Lake Forest Park
STRIDE S3 SR522/145 BRT LFP Impacts

Citizens Organized to Rethink Expansion
CORE
522 in LFP

LAKE FOREST PARK 60% ALIGNMENT OVERLAY

This alignment overlays the 60% landscape plans on SR522/145 BRT LFP

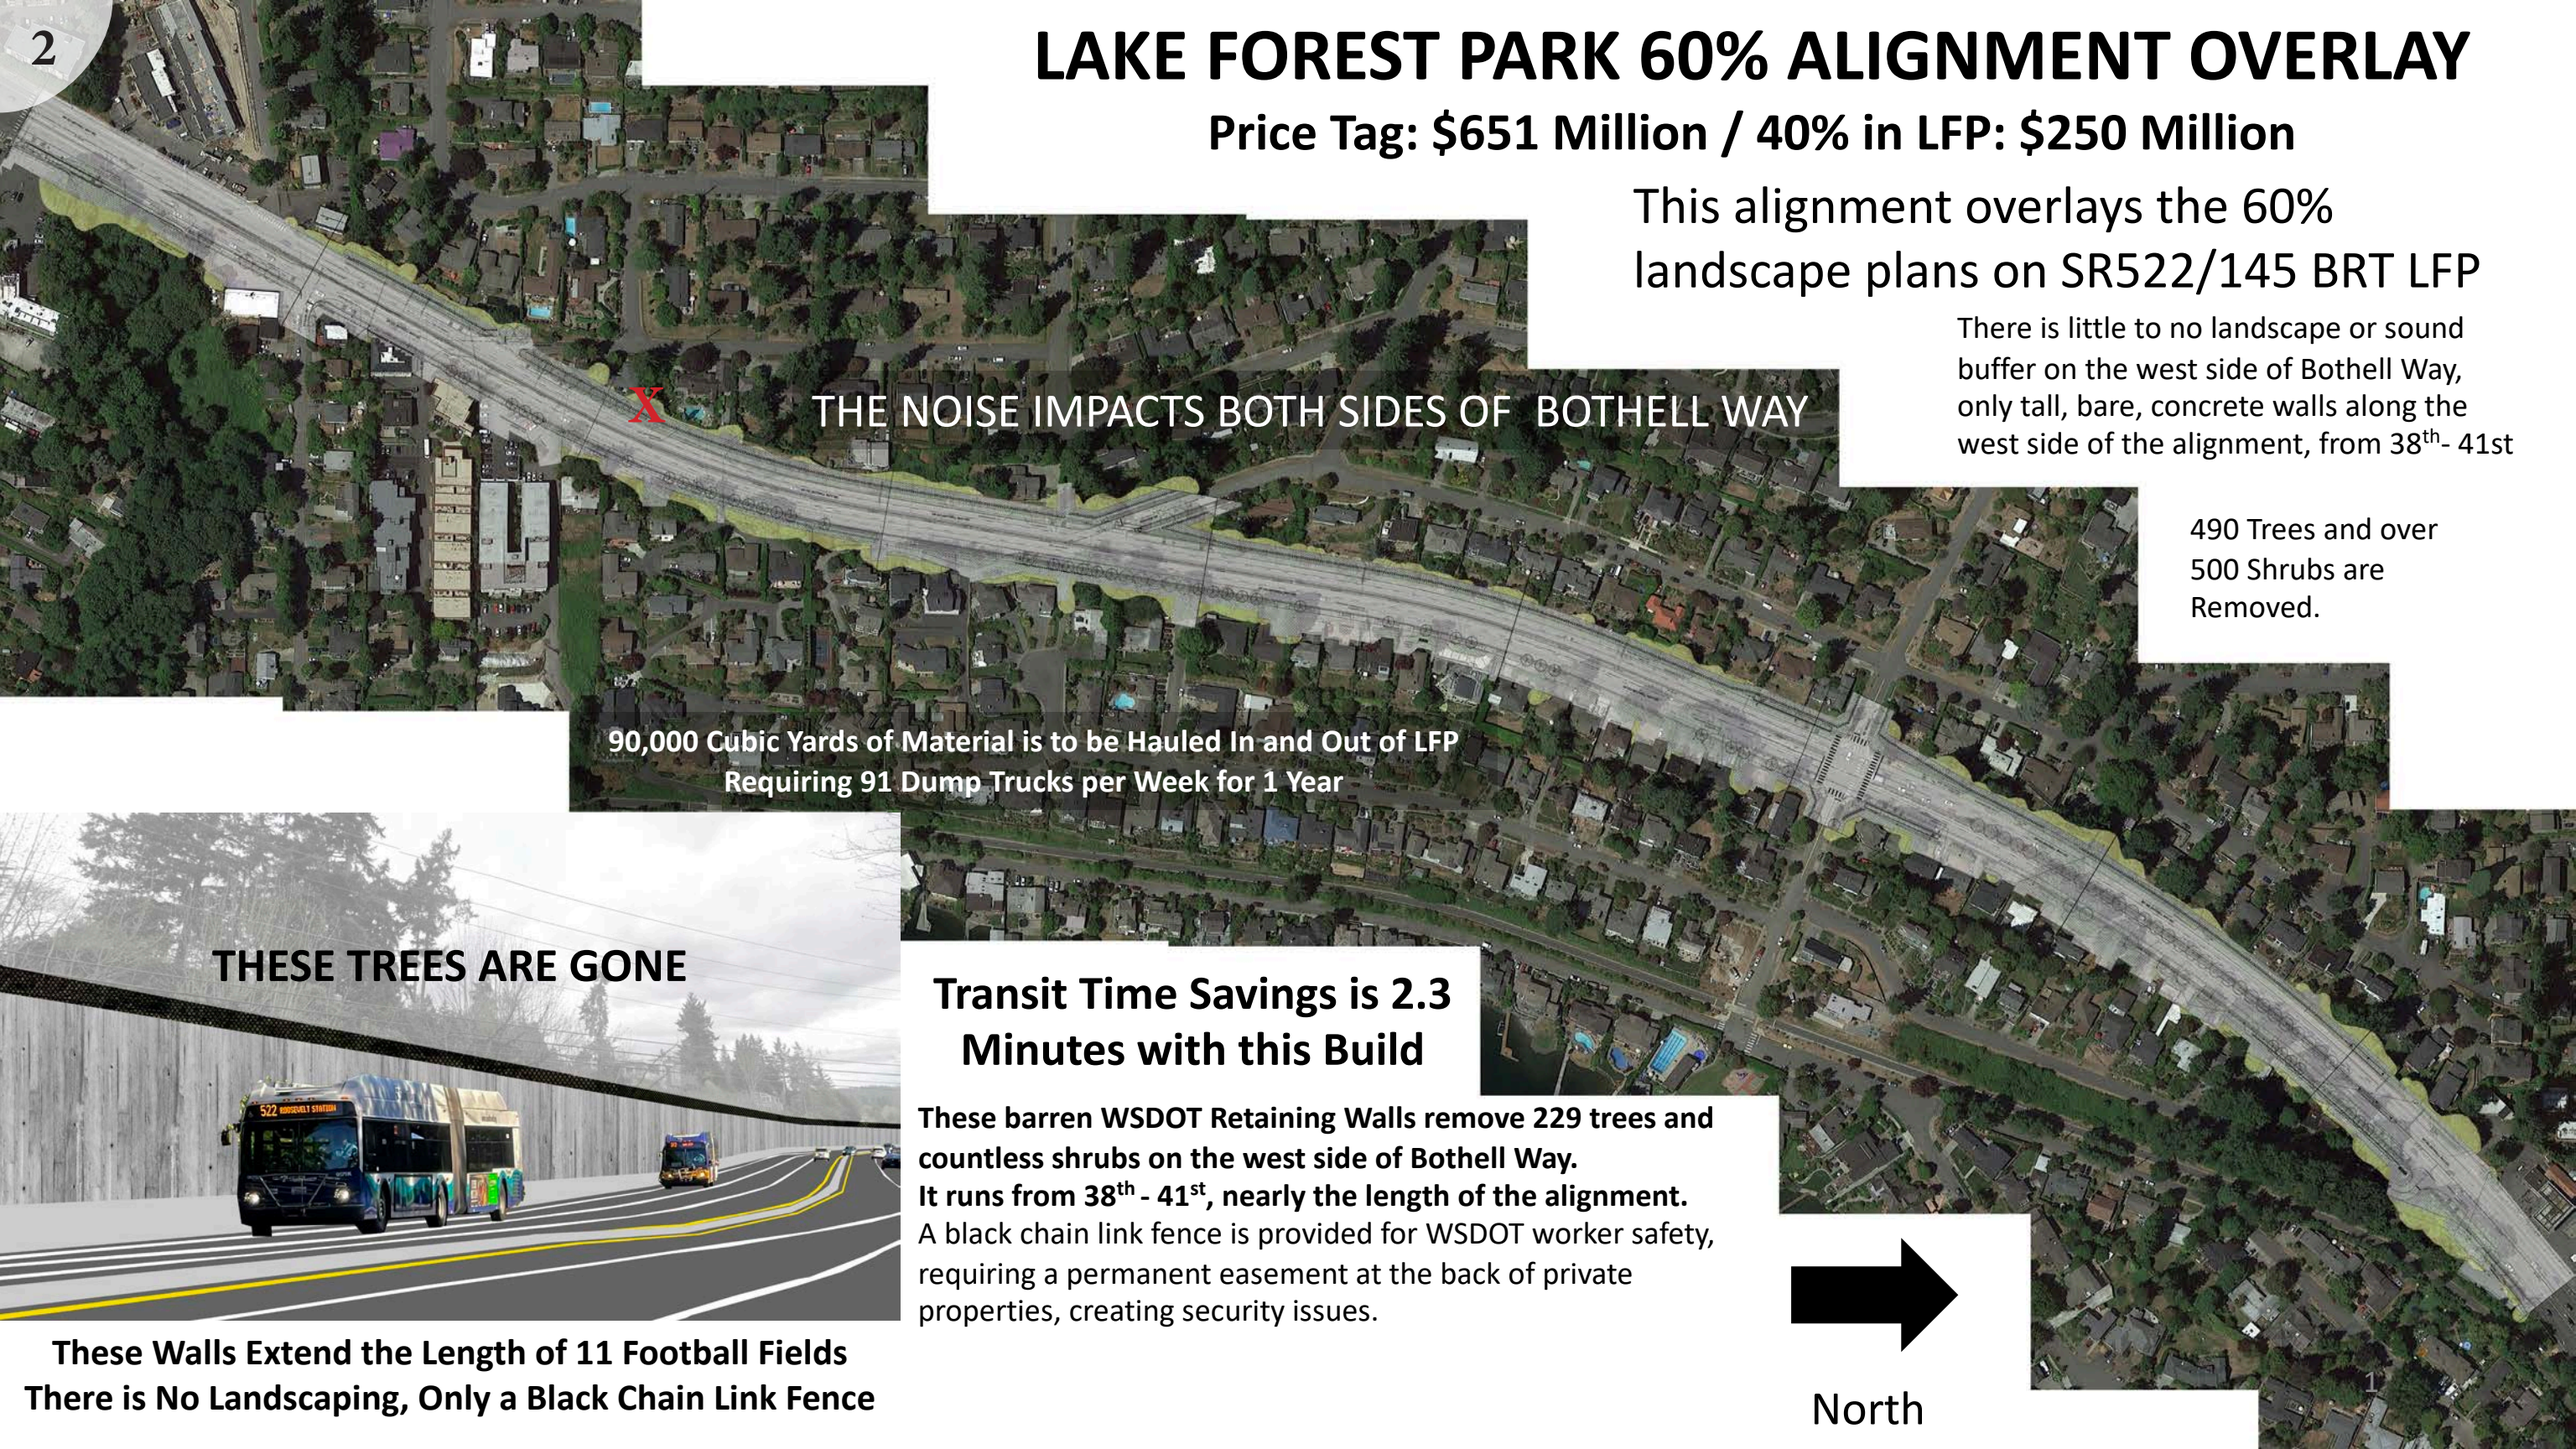
There is little to no landscape or sound buffer on the west side of Bothell Way, only tall, bare, concrete walls along the west side of the alignment, from 38th- 41st

490 Trees and over 500 Shrubs are Removed.

These barren WSDOT Retaining Walls remove 229 trees and countless shrubs on the west side of Bothell Way.
It runs from 38th - 41st, nearly the length of the alignment.
A black chain link fence is provided for WSDOT worker safety, requiring a permanent easement at the back of private properties, creating security issues.

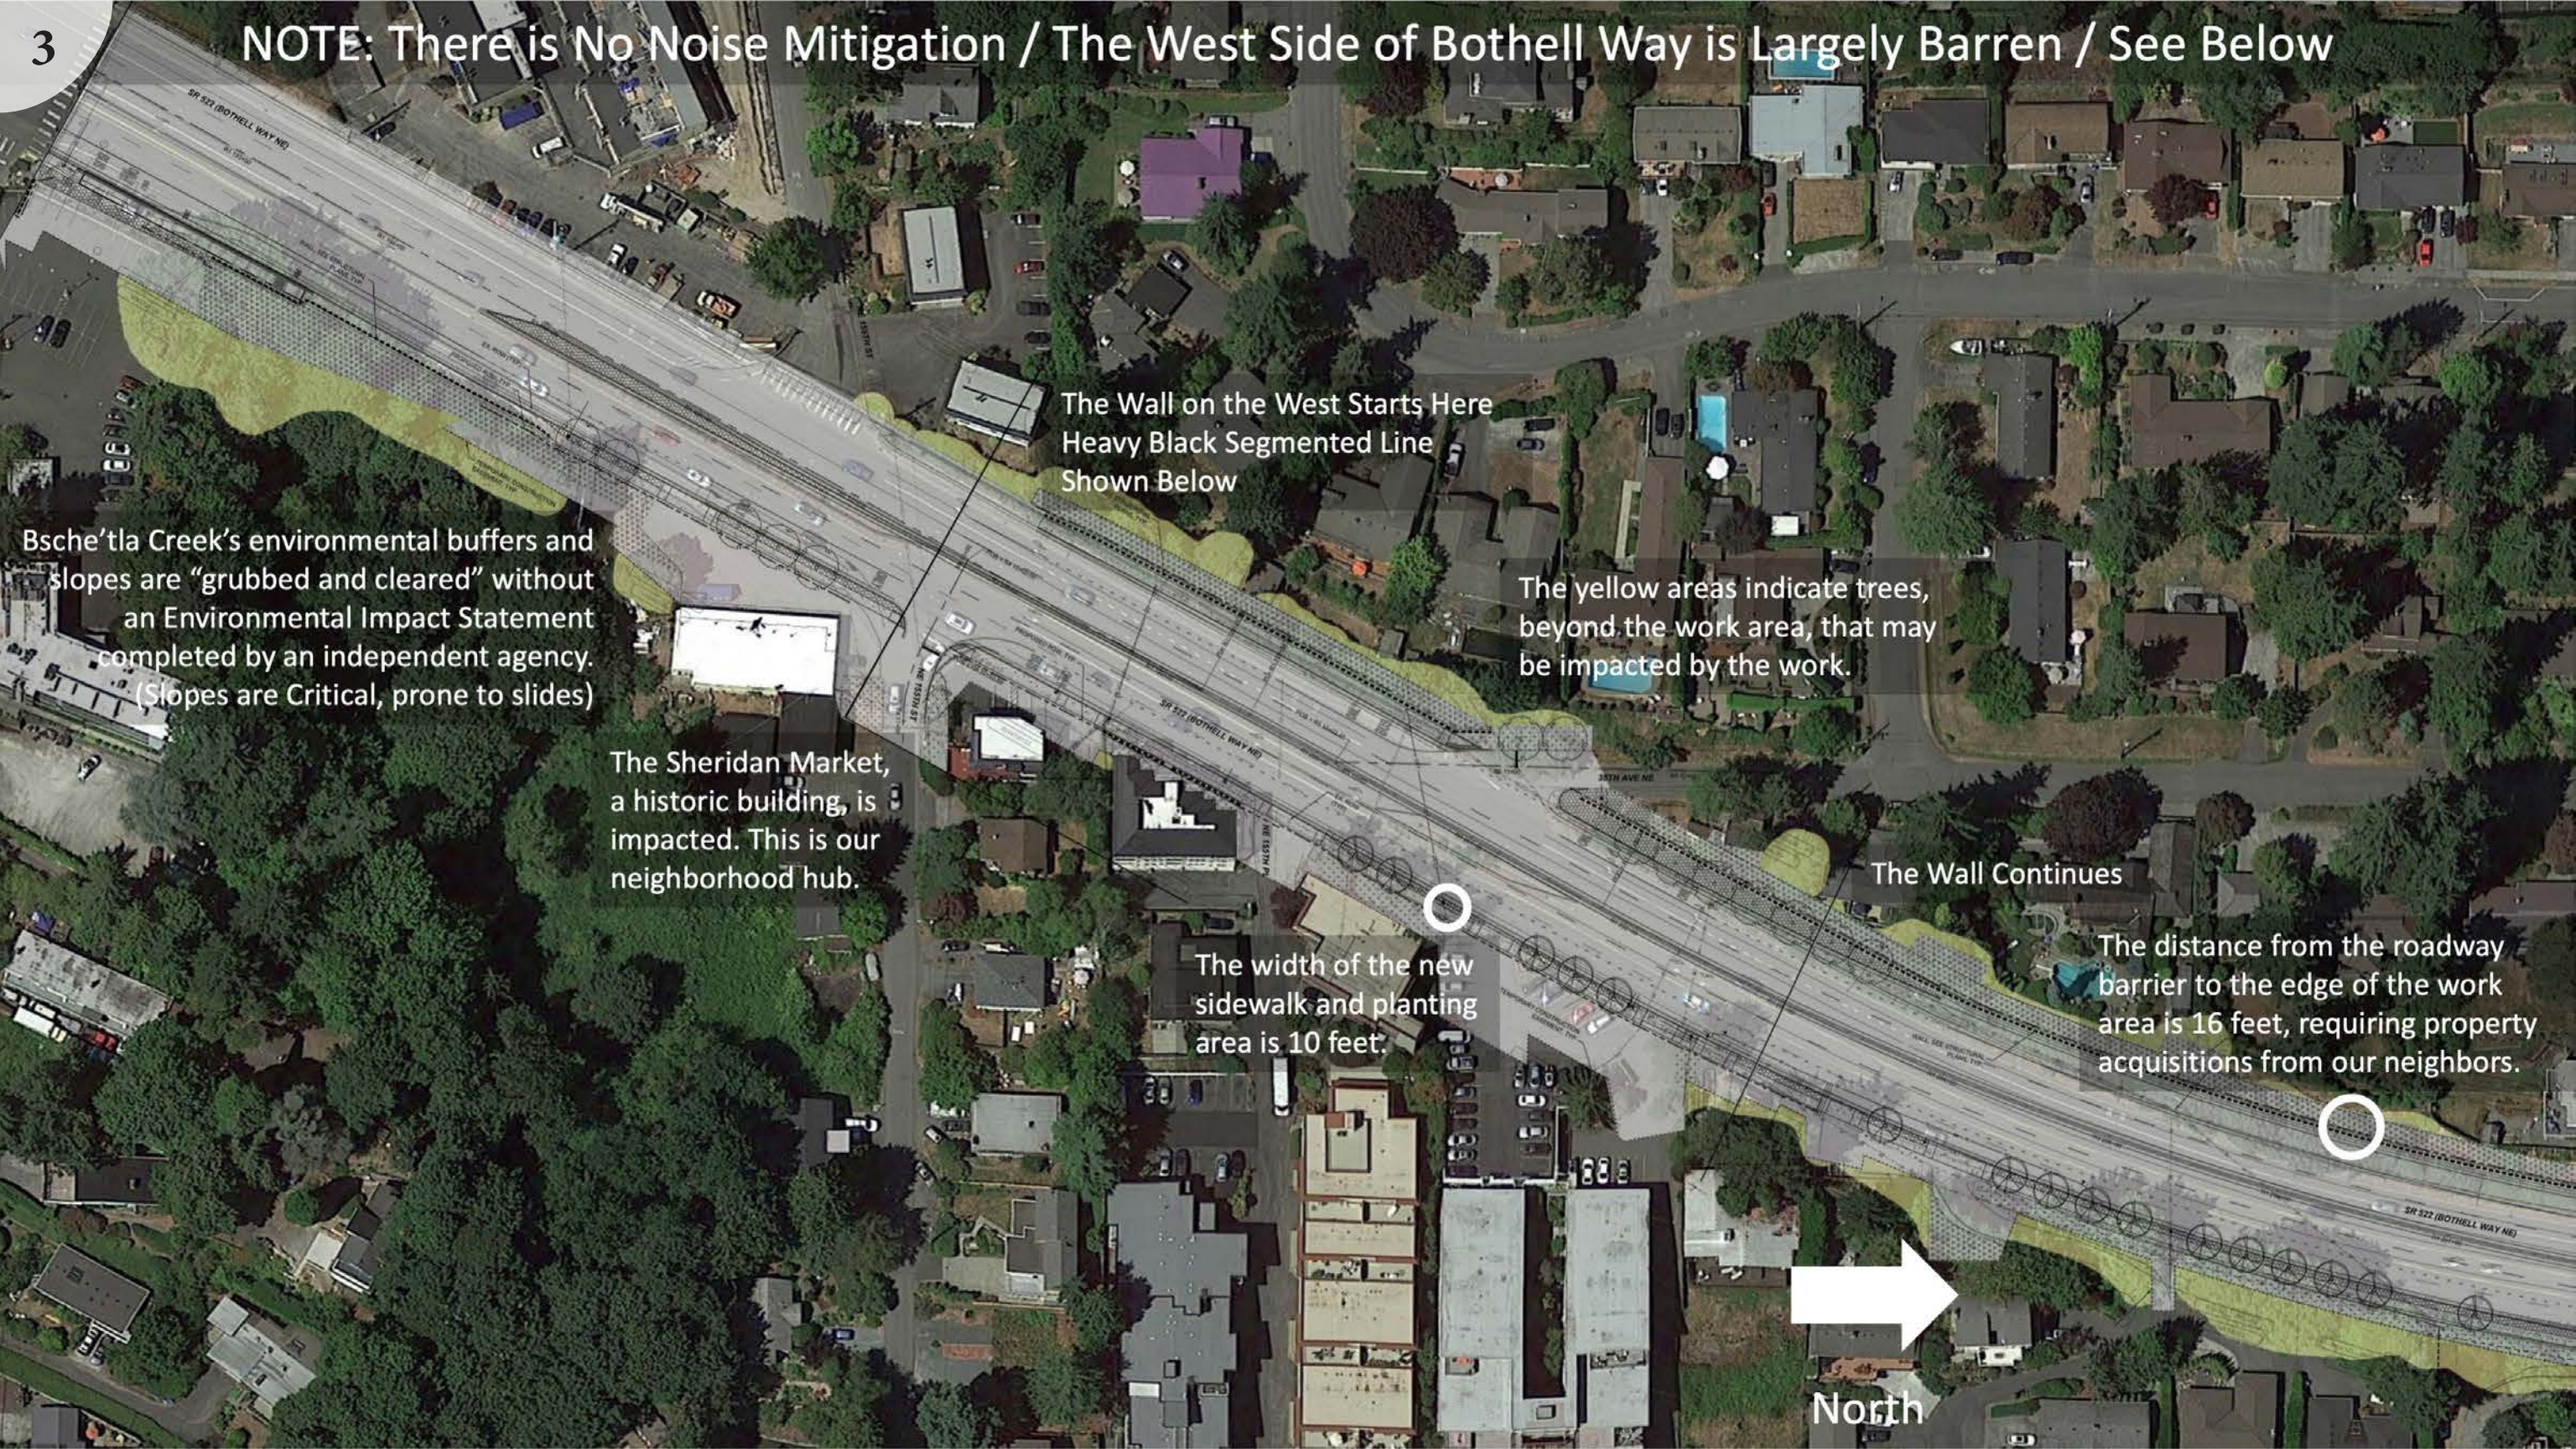
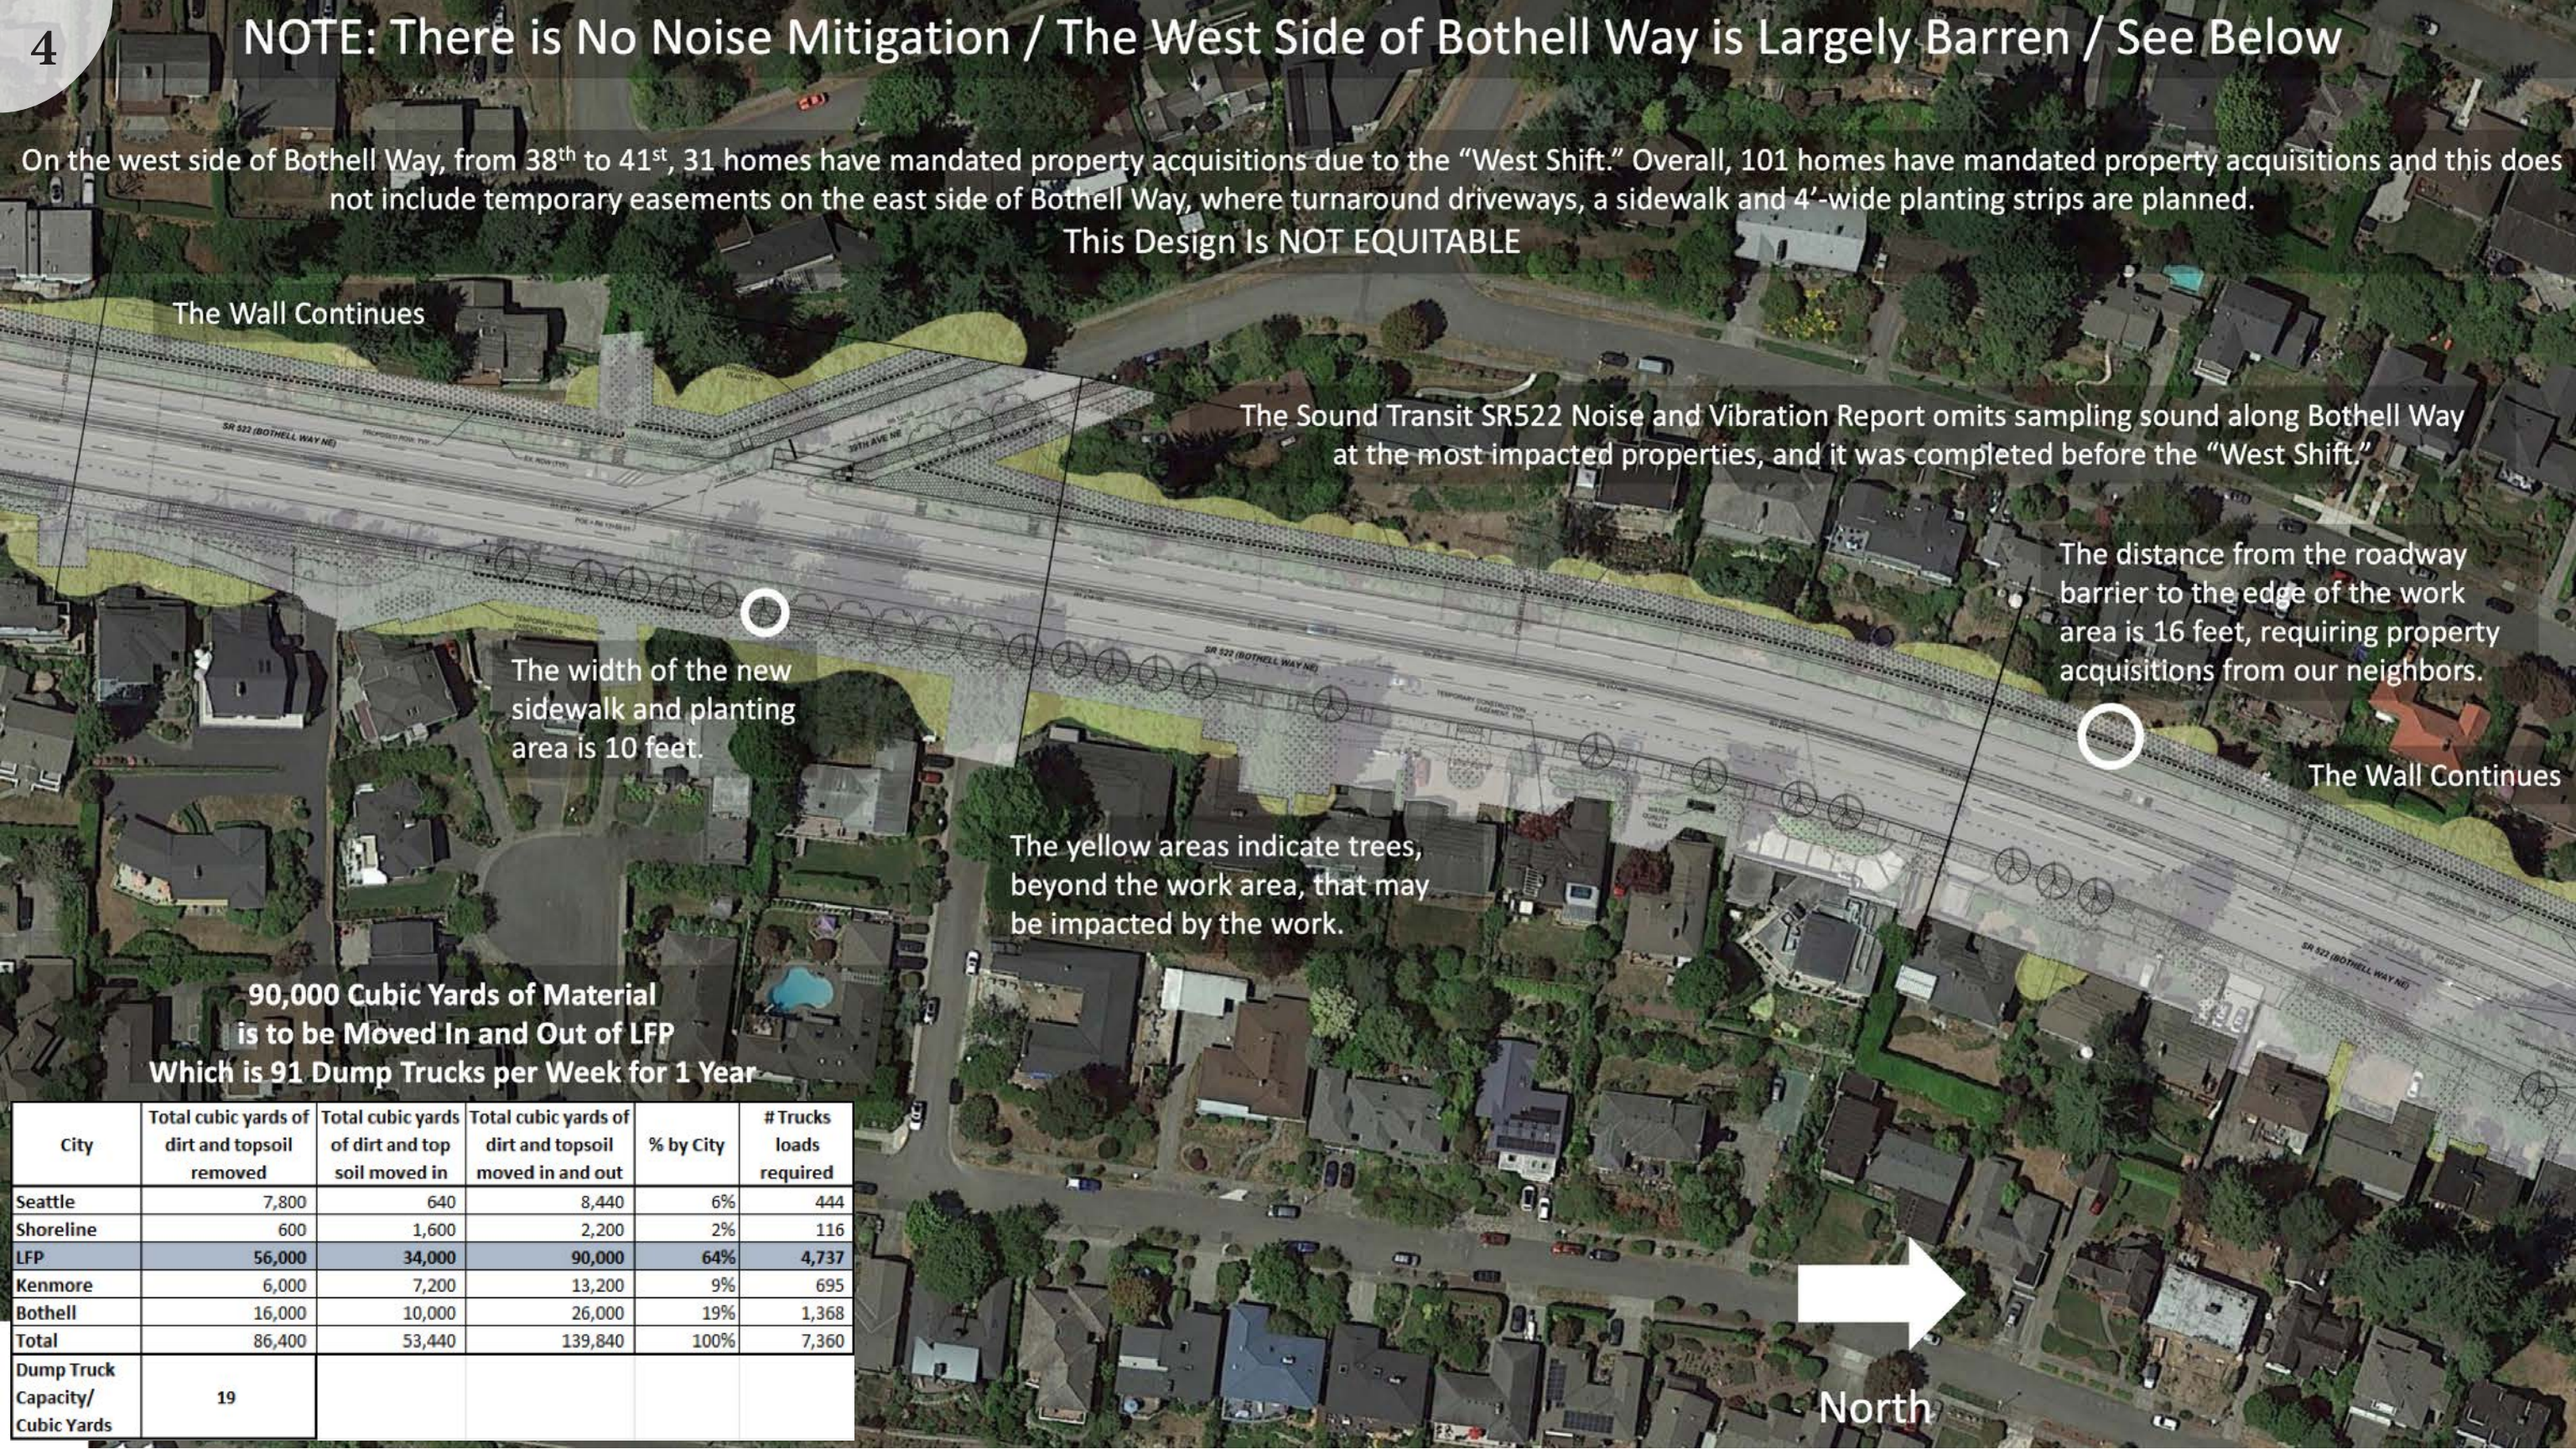
NOTE: There is No Noise Mitigation / The West Side of Bothell Way is Largely Barren / See Below

On the west side of Bothell Way, from 38th to 41st, 31 homes have mandated property acquisitions due to the "West Shift." Overall, 101 homes have mandated property acquisitions and this does not include temporary easements on the east side of Bothell Way, where turnaround driveways, a sidewalk and 4'-wide planting strips are planned.

This Design Is NOT EQUITABLE
